Subject: Addendum No. 2 – Request for Expressions of Interest (RFEI) for
Development of Brooklyn College School of Business.

Date: August 9, 2018

**REQUEST FOR EXPRESIONS OF INTEREST (RFEI)
FOR THE DEVELOPMENT OF BROOKLYN COLLEGE SCHOOL OF BUSINESS
Addendum No. 2
Responses to RFEI Questions
August 9, 2018**

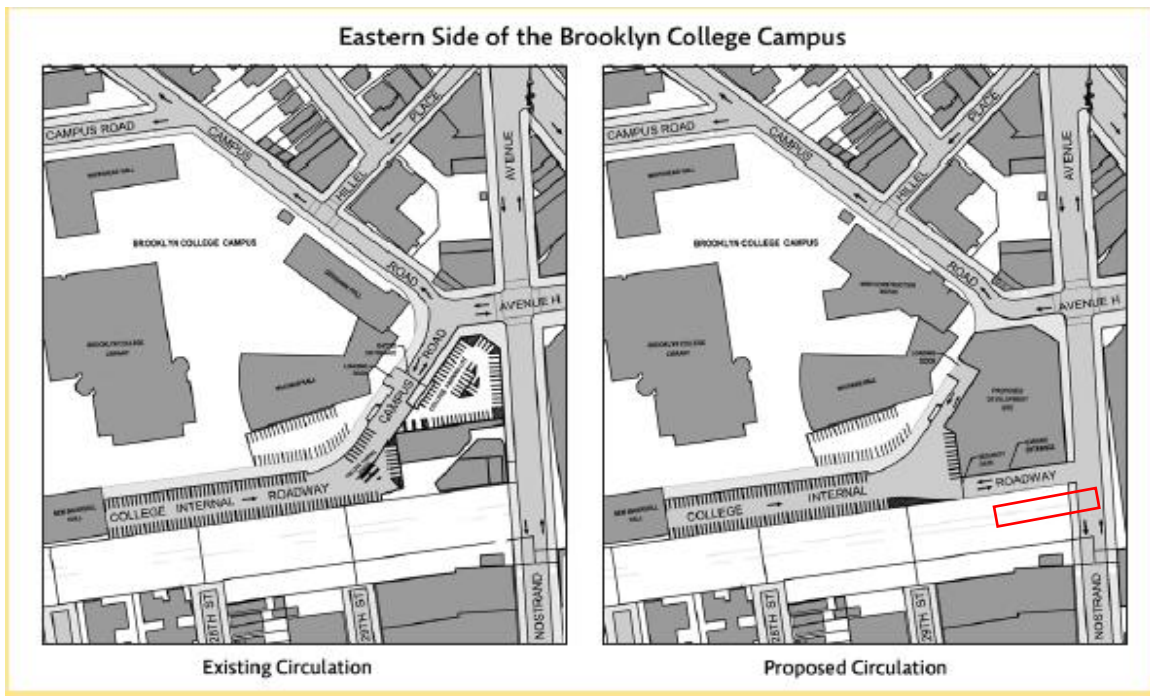
1. **With respect to the 15,000 square foot de-mapped piece of land, please confirm that the lot will have road access (not land-locked).**

The de-mapped piece of land is a continuation of Avenue H. Once the de-mapped portion of the street is purchased from the City of New York, the current development plan includes the creation of a new roadway that will connect the existing College Internal parking lot to Nostrand Avenue. The new roadway is shown below on the Proposed Circulation Map in red.
